1.1. Old Business

Application to the HISTORIC DISTRICT COMMISSION, Nantucket, Massachusetts, for a

CERTIFICATE OF APPROPRIATENESS

DECK AND POOL PATIO

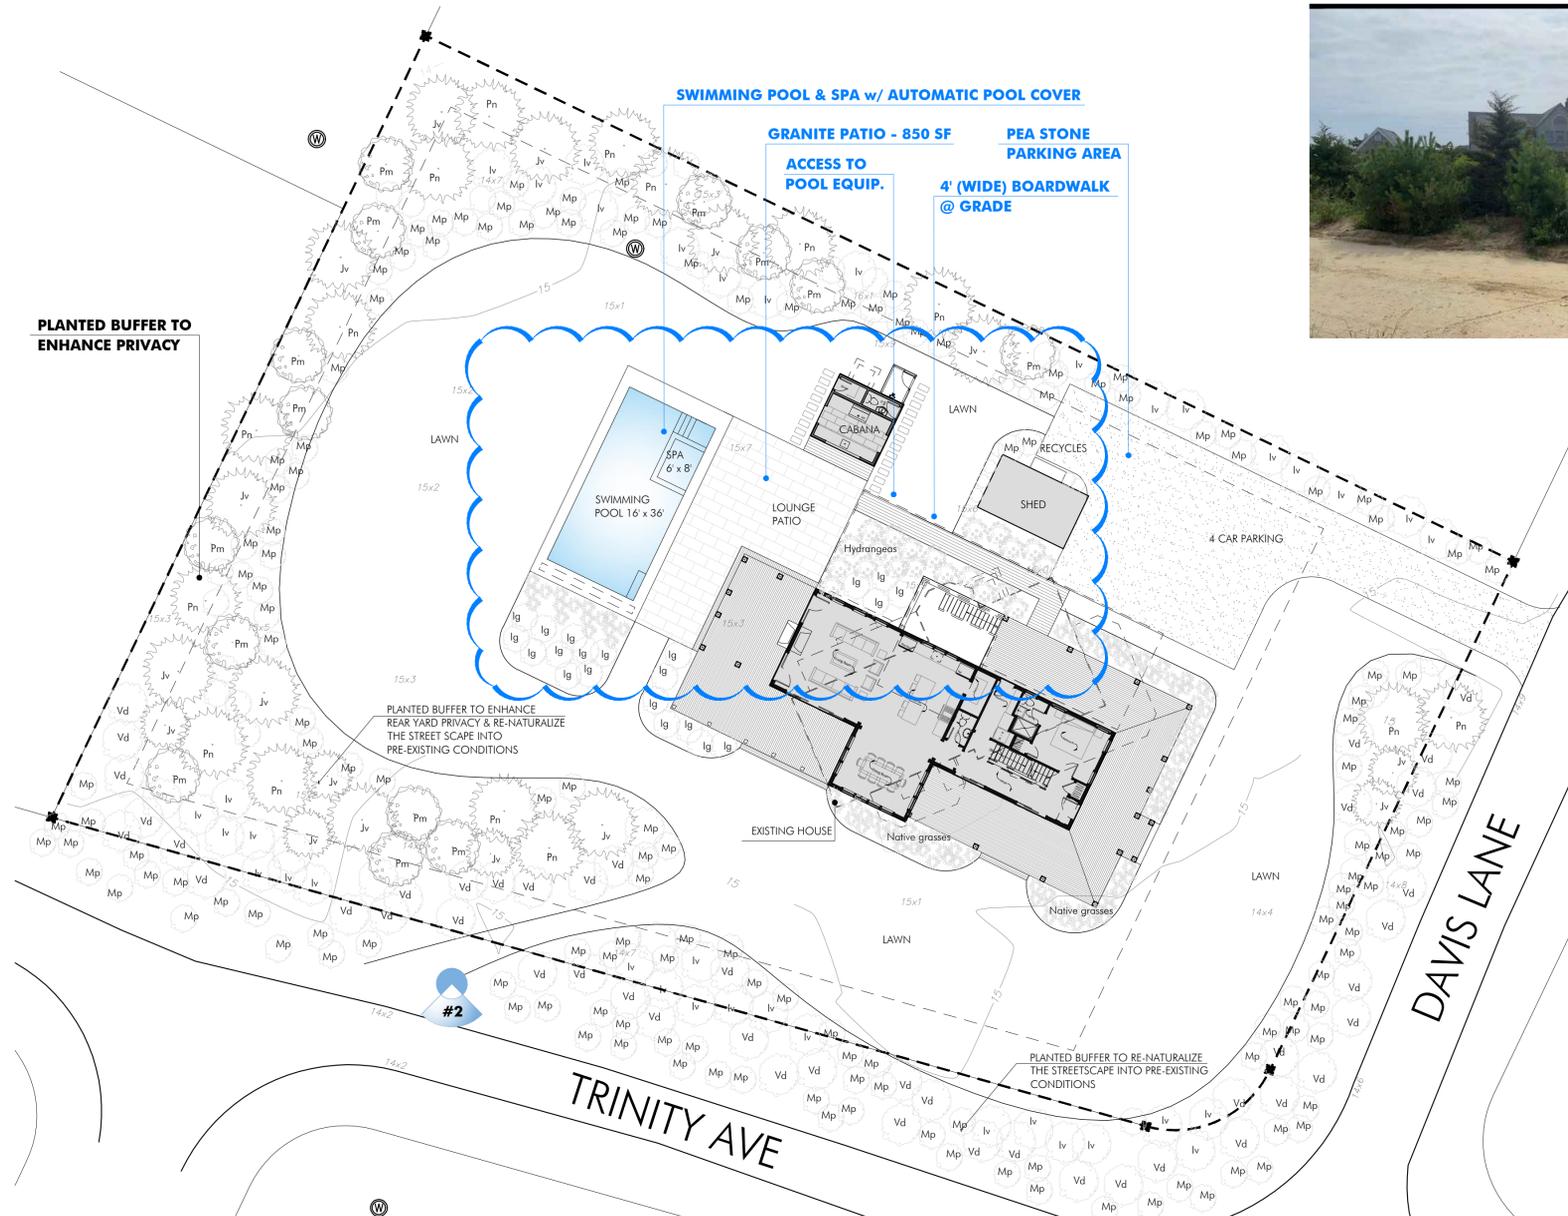
Erisman – This area has small lot sizes with low vegetation; the prior owner cleared the lot beyond his bounds. He doesn't know how to restore natural vegetation without looking manufactured. Cisco is natural wilderness with houses mixed in. It looks like there are attempts at perimeter vegetation but he's not sure what will be done around the immediate pool. Feels this is an exploitation of the area which jeopardizes the quietude of Cisco. He hopes that if the new owners spend some time in Cisco, they will have a change of heart. This pool is more than 100 square feet (SF) and the cabana a beacon of light and noise in the open landscape.

Gagliano – There's not a lot of detail on what's happening on the northern end. Cedars and pitch pines can grow to over 30 feet and the grouping at the perimeter would create a wall; no other areas of Cisco have that type of border. The pool is large and there is visibility of the cabana from the three roads. This whole complex is about 3,000 SF of hardscape; that footprint is bigger than the house; this sits in the middle of a natural area and is different from everything in the area. Can't emphasize the quietude, low moors, and night sky that is this area. Once we lose what we have, we will never get it back.

Coombs – This is inappropriate for this area, which is roving, ranging moors and always has been. This doesn't need to be paved and landscaped with plants all around it, like New Jersey. Feels there is no need for the pool, cabana, and associated landscaping to be larger than the house; the neighbors have as much right to enjoy their properties as this owner. The pool and hardscaping need to be reduced. Fencing isn't shown.

Camp – Cisco is an area of sandy roads across moors to the dunes. The way the trees are located around the perimeter will take away from the beauty and openness of the area; it's unnatural. Pull the screening closer to the pool and leave it open around the outside. We need a rule that says you can only brush cut what is needed to do any work. Wonders about the Zoning and Planning Boards, who are saying you can have pools here. Don't turn this into suburbia. The pool is too large.

Welch – Agrees with what's been said; particularly shielding the pool not to be visible from the street; these types of landscape plans start to make this Masaquet Avenue; Cisco is open space, which is a historical setting that should be preserved. We do have control over the setting, how proposed structures present themselves to the historic setting, size of pool, location of the cabana, concept of cluster, and shrinking the area that needs to be screened. He'd like to see an aerial mockup of the proposed along with the neighboring structures.

Pohl – Agrees with much that's been said. Moving plantings closer to the problem area will make the screening more effective without making it look like the owners are fencing themselves off from the neighborhood. North side of the property lacks screening. Equipment should be in the basement.

Motion **Motion to Hold for revisions and a more significantly detailed planting plan and reduction in the pool size. (Oliver)**

PROPOSED NORTH ELEVATION

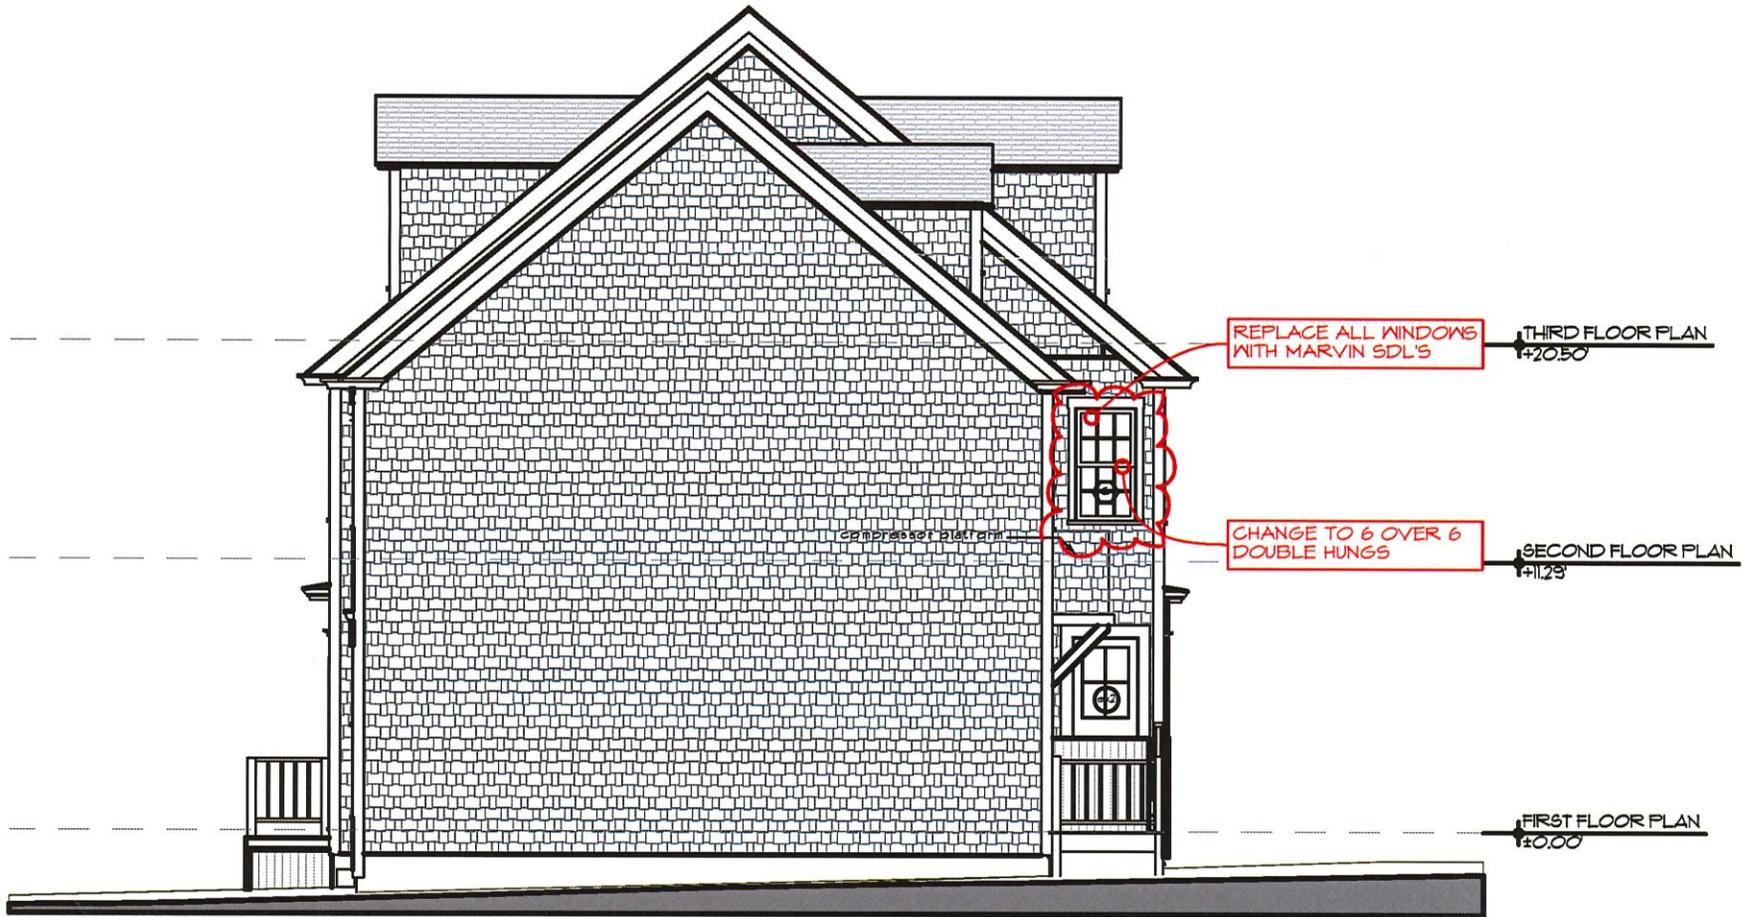
- REPLACE ALL WINDOWS WITH MARVIN SDL'S
- CHANGE TO 6 OVER 6 DOUBLE HUNG
- REPLACE ALL WINDOWS WITH MARVIN SDL'S

Previously Proposed North Elevation - Garage

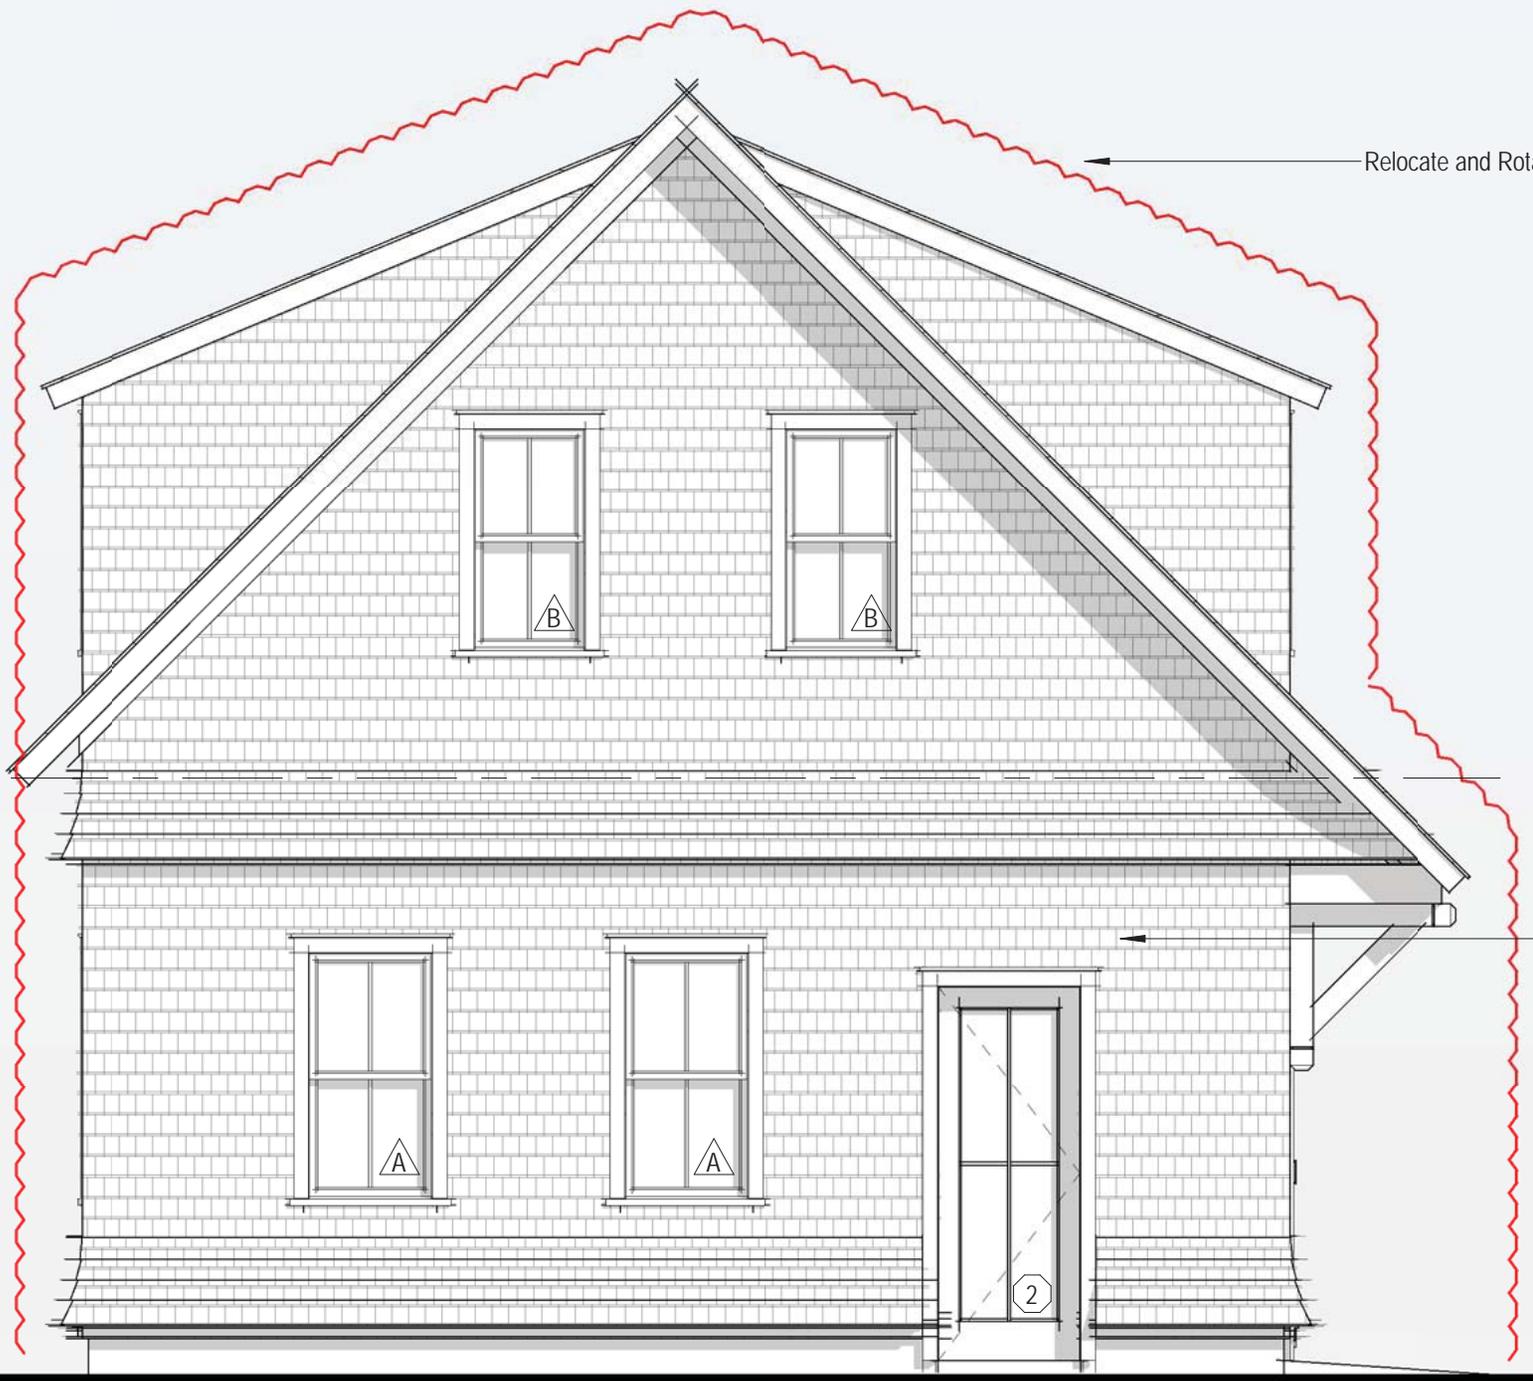
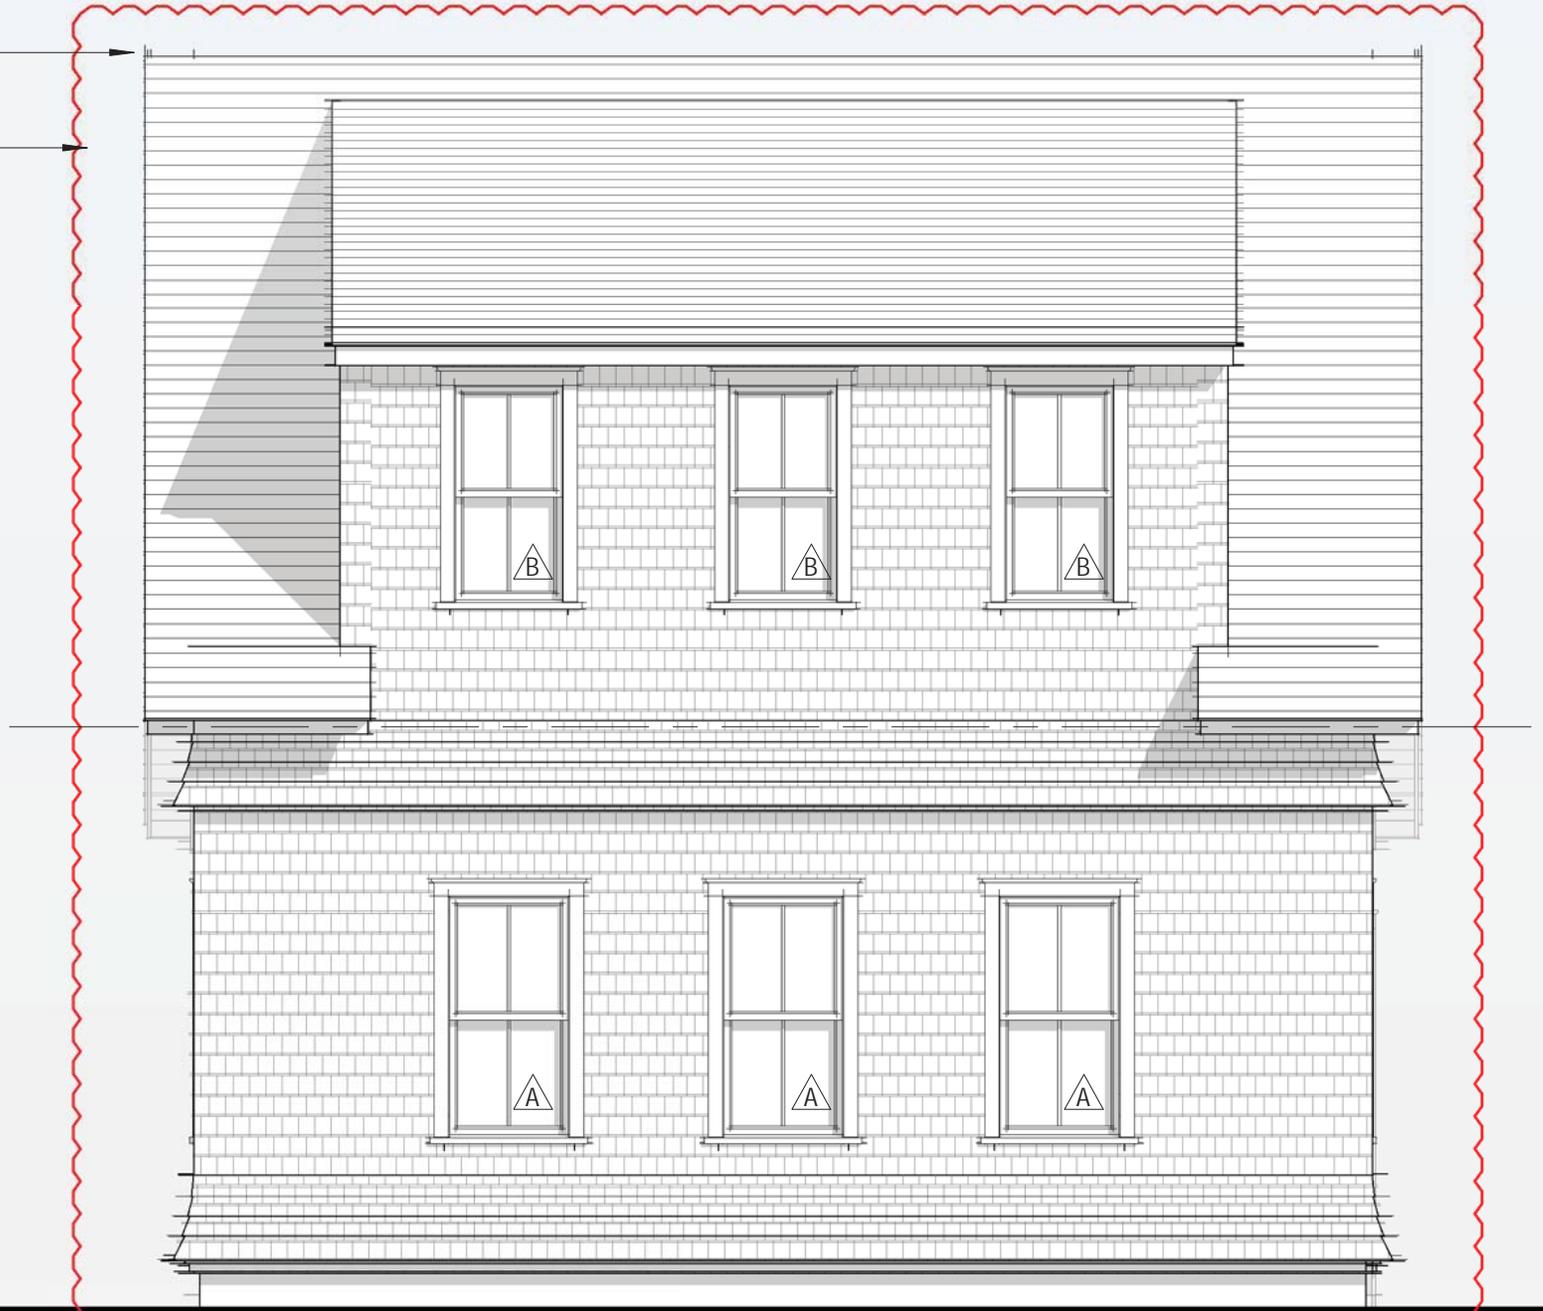
Relocate and Rotate Building

5 West Elevation

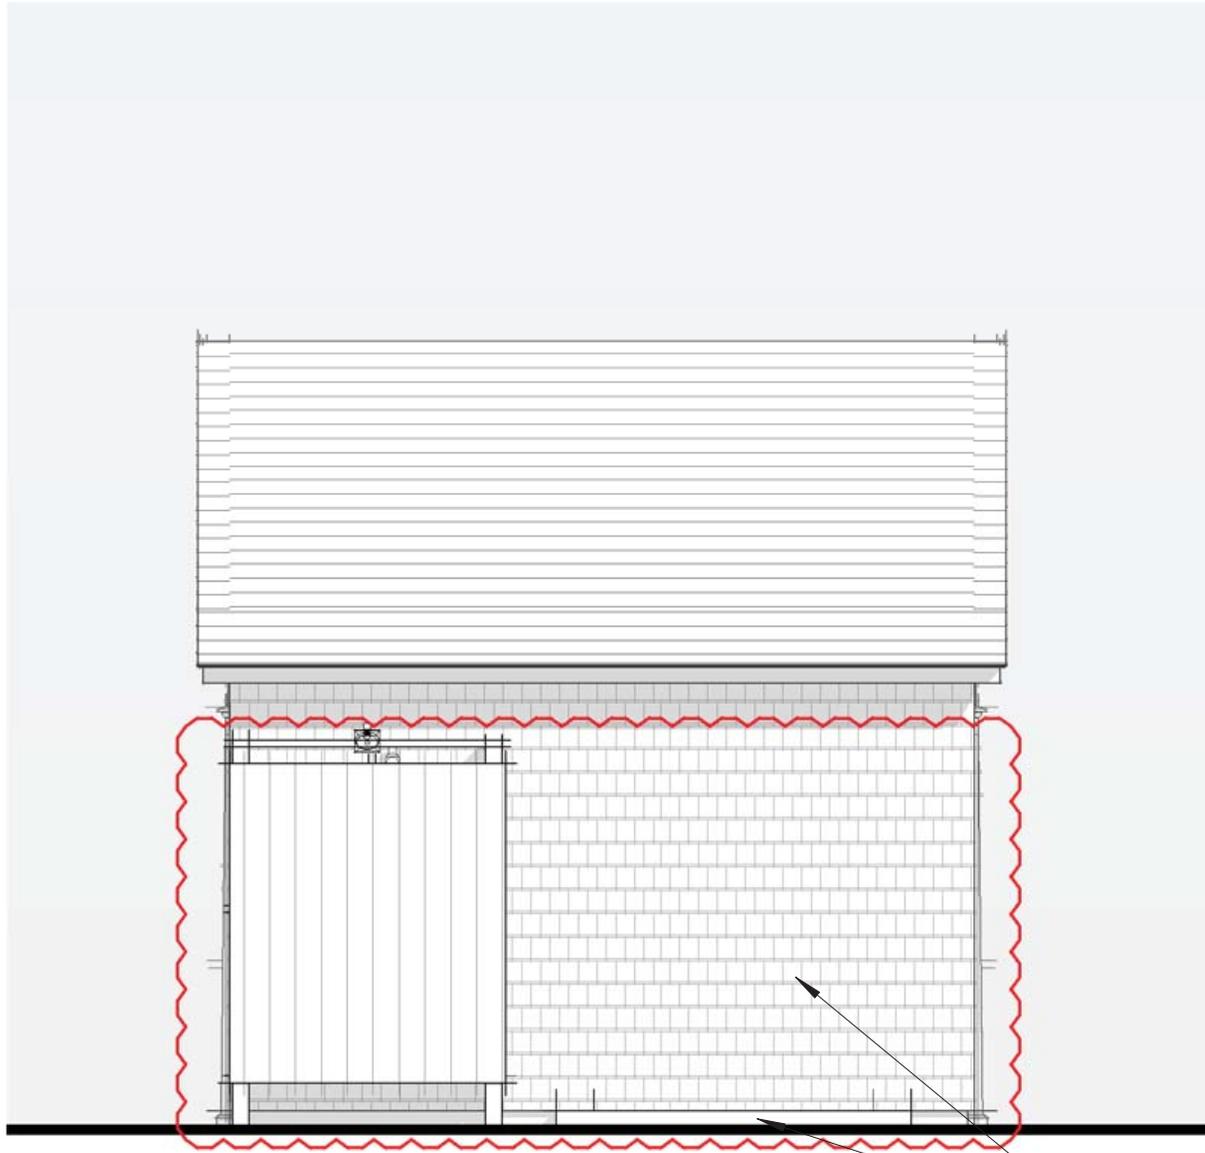
Omit Pool Equipment fence and
add crawl space access well
